**Notice of Intent**

Type of Action Plug and Abandonment

**HILCORP ENERGY COMPANY**  
**TRIBAL C 1**  
**P&A NOI**

## BLM FLUID MINERALS Geologic Report

## TRIBAL C 1 - PROPOSED WELLBORE SCHEMATIC

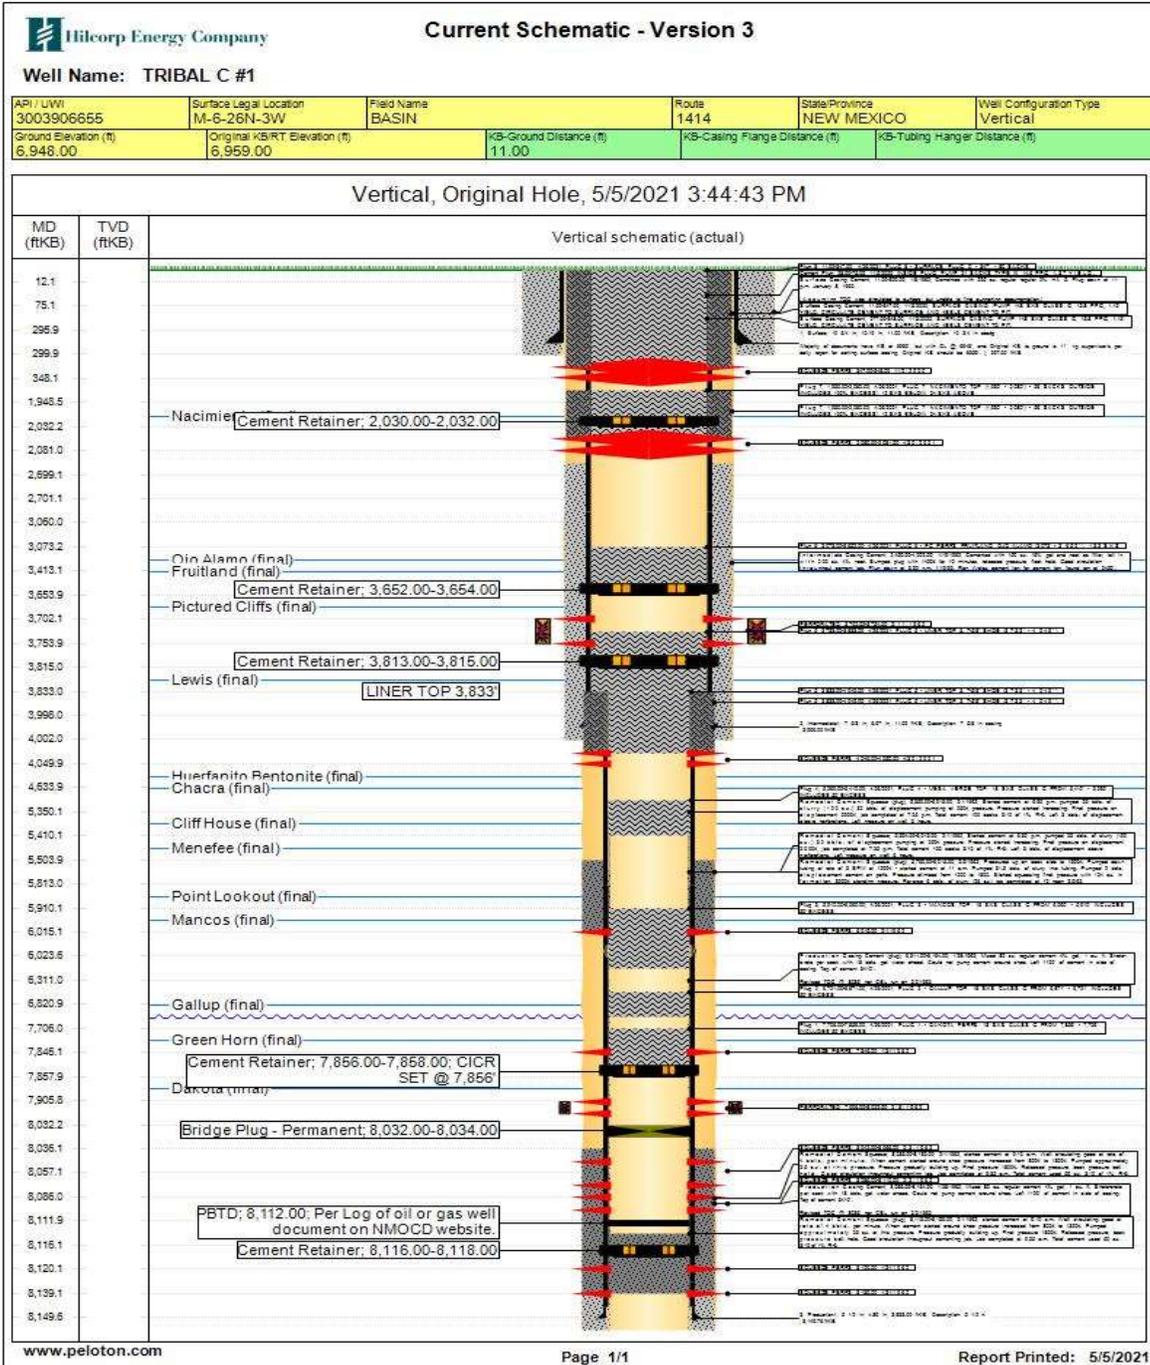
1. Plugging operations authorized are subject to the attached "General Requirements for Permanent Abandonment of Wells on Federal and Indian Lease."
2. Farmington Office is to be notified at least 24 hours before the plugging operations commence (505) 564-7750.
3. The following modifications to your plugging program are to be made:
  - a) Set Plug #6 (3073 - 3723) ft. to cover PC, Fruitland, Kirtland, and Ojo Alamo tops. BLM picks top of Pictured Cliffs at 3673 ft. BLM picks top of Ojo Alamo at 3173 ft.

- BLM formation top pick for the Pictured Cliffs varies from Operator pick.
- Plug #6 (Pictured Cliffs perforations, Fruitland and Ojo Alamo tops) bottom should be brought down to cover BLM Pictured Cliffs formation top pick @ 3673'.
- A Chacra plug is not required as this well is off the productive gas trend.
- Log analysis of Reference Well #2 indicates the San Jose, Nacimiento, and Ojo Alamo sands may contain fresh water (< 5000 ppm TD). Placement of cement plugs as indicated on the P&A procedure, with recommended adjustments from this report, will protect fresh water sands in this well bore.
